**REZONING, PUD &
SUBDIVISION STAFF REPORT****Date: May 5, 2005****APPLICANT NAME**

The Quarters at Heron Lakes

REQUEST Rezoning from R-1 and R-3 to R-3, Planned Unit Development, Subdivision

SITE PLAN

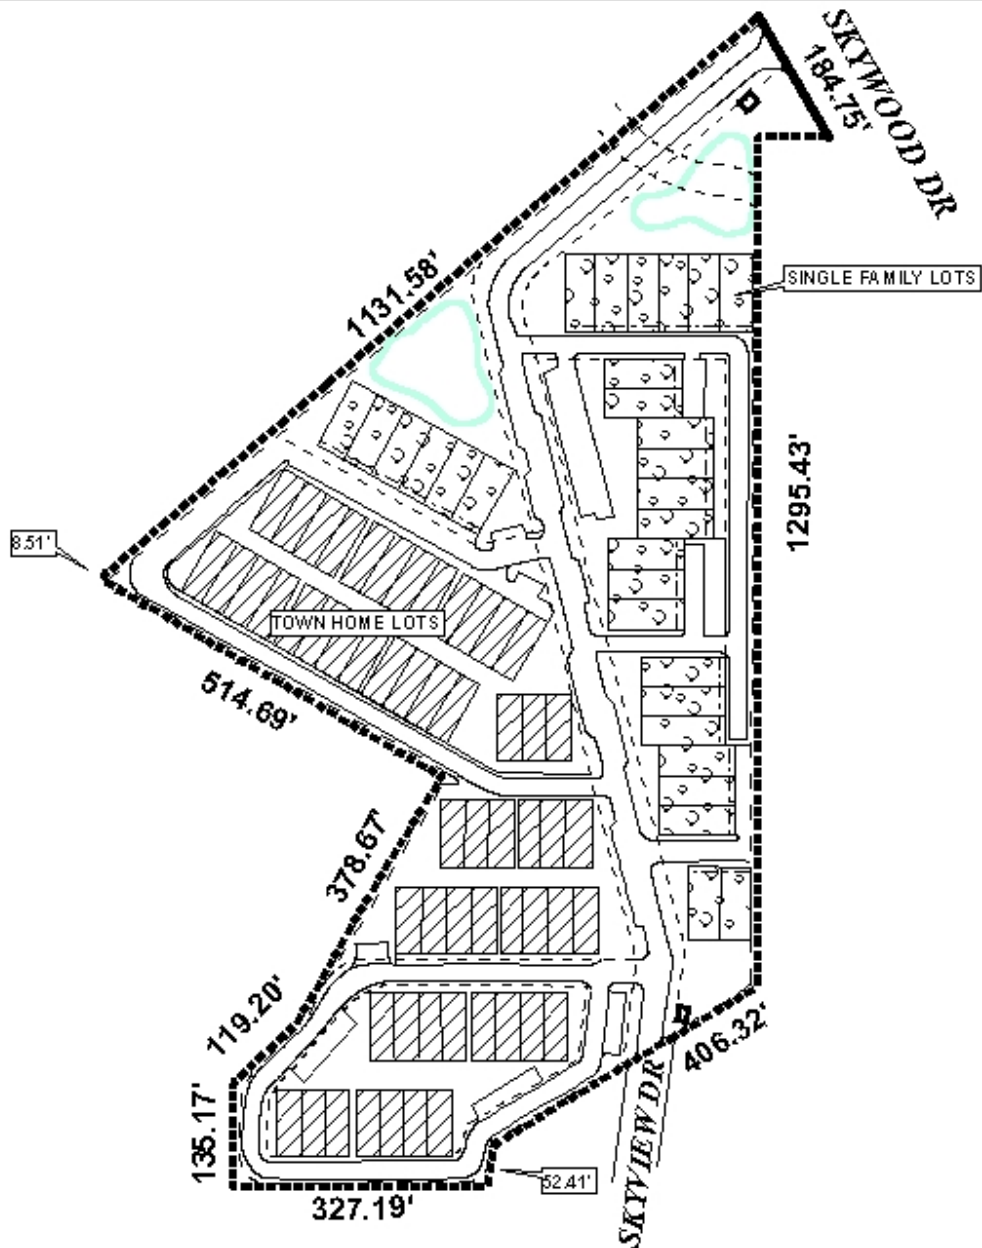
While this is an innovative development and appears to meet the general requirements for rezoning, PUD approval, and innovative subdivision approval, there are some minor issues relating to the plan that should be addressed prior to any type of approvals. These issues relate to building separation / setbacks, and possible adjustments to the private street / parking locations (indicated in attachment to application). These issues are of concern because PUD approval is site plan specific. Minor modifications, such as relocation of a drive way or a minor shift in building location, may be reviewed and approved administratively. However, more significant changes such as revision to setbacks for the

entire development (or a large portion thereof) or changes in location or design of the private street and parking facilities would require a modification or amendment to the PUD, and approval by the Planning Commission. Another issue that is not addressed in the application, but was referenced at a neighborhood meeting is that the access to Skyview Drive is to be for emergency vehicles only. The plan submitted indicates that it would be an exit only, with no reference to emergency vehicles. Changing this to emergency vehicle access only would necessitate a modification to the plan to provide a turn-around.

Rezoning: based on the preceding, it is recommended that this application be heldover until the June 2nd meeting to allow the applicant to submit revisions that address the issues referenced in the staff report (verification that density could be supported by R-2 zoning, building separation / setbacks, possible adjustments to the private street / parking locations, provision of a turn-around at the Skyview Drive gate). Revisions and additional information must be submitted by May 9th to be considered on June 2nd.

Planned Unit Development: based on the preceding, it is recommended that this application be heldover until the June 2nd meeting to allow the applicant to submit revisions that address the issues referenced in the staff report (building separation / setbacks, possible adjustments to the private street / parking locations, provision of a turn-around at the Skyview Drive gate). Revisions and additional information must be submitted by May 9th to be considered on June 2nd.

Subdivision: based on the preceding, it is recommended that this application be heldover until the June 2nd meeting to allow the applicant to submit revisions that address the issues referenced in the staff report (building separation / setbacks, possible adjustments to the private street / parking locations, provision of a turn-around at the Skyview Drive gate). Revisions and additional information must be submitted by May 9th to be considered on June 2nd.
